UNITED STATES PATENT AND TRADEMARK OFFICE

| APPLICATION NO. | FILING DATE | FIRST NAMED INVENTOR | ATTORNEY DOCKET NO. | CONFIRMATION NO. |
|--|-------------|----------------------|------------------------------|------------------------|
| 10/532,518 | 04/25/2005 | Thomas Dunker | Dunker, T. ET AL - 1 PCT | 6031 |

| Office Action Summary | Application No. 10/532,518 | Applicant(s) DUNKER ET AL. | |

DETAILED ACTION

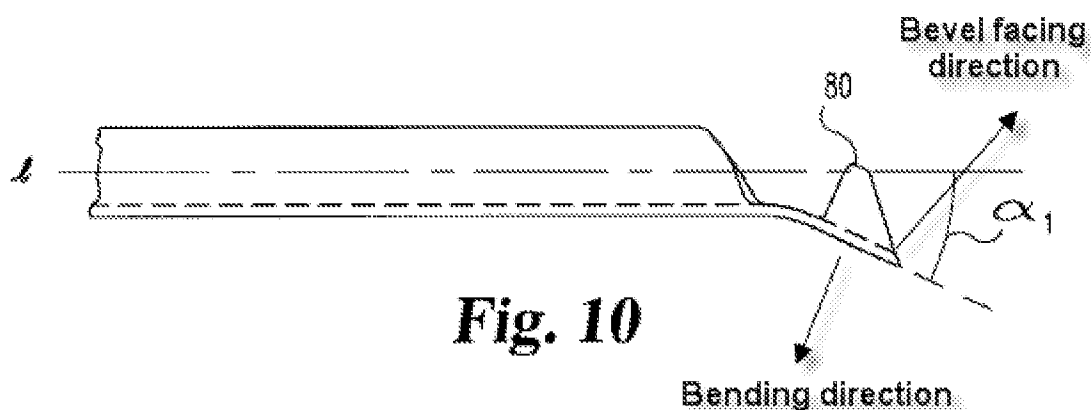
Miller teaches a biopsy holding device comprising a flexible distal section having a proximal and distal and a tip at said distal end with beveling arranged at the tip (cutting edge 81, see Figures 10 and 11 and Column 5, Lines 9-32), said distal section being bent in a bending direction at a pre-stress angle arranged at the proximate end of the distal section (Figure 10 shows the distal section being bent at an angle α_1 in a bending direction),

said beveling facing away from the bending direction (see Figure 10 above), so that the wire including the wire tip glides along the inner wall of the biopsy cannula when
